Intel Technical Advisory

TA-0948-1

Intel® Server Systems SR1625, SR2600, and SR2625 may not be able to load Linux OS or IDA from Optical Drive

Figure 1: SR1625 Backplane (PBA# E27104-403) - Location U4L2

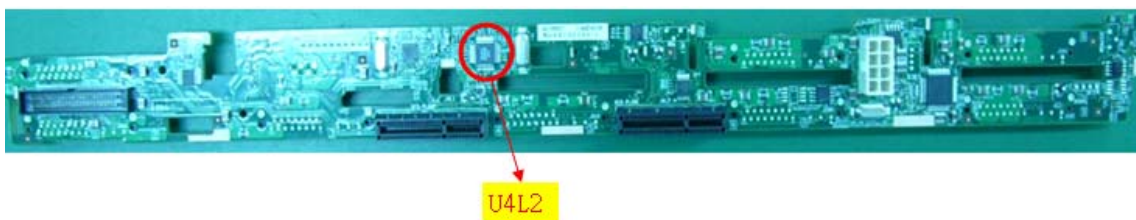
The backplanes suspected to be built with the incorrect GL830 can first be identified by the system serial number list above. To confirm, the markings of the GL830 converter must be visually inspected. The GL830 is located on the rear of each backplane as shown in figures one, two and three. For each system, this component is visible after removing the top cover without removing any other parts from the system. Incorrect parts have a '02' suffix, see figure 4, while the correct parts have a '03', see figure 5.

If you have one of the affected systems and would like a replacement backplane, please contact Intel using your normal warranty process, indicating that you are calling regarding TA# 0948-1. Have the following information when you call: the PBA# of the backplane and the MM#, Product Code, and serial number of the affected system(s).

Figure 4: Incorrect GL830

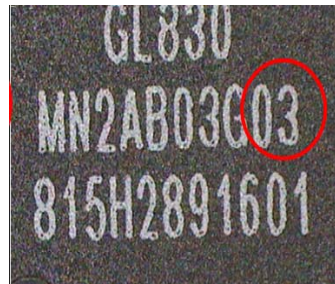
The backplanes of some SR1625, SR2600, and SR2625 systems have been built with an incorrect version of the GL830 converter. It is not possible to load a Linux OS or the Intel Deployment Assistant on a system using a backplane with the incorrect GL830 component. The failure mode will vary depending on the specific version of Linux used but can include a hang or kernel panic.

All products shipped on or after March 23rd are confirmed to not be affected by this issue. Any system not listed in the Products Affected table above should not be affected by this issue. Additionally, an inspection has been added to confirm that all new shipments of the GL830 component are of the correct revision.
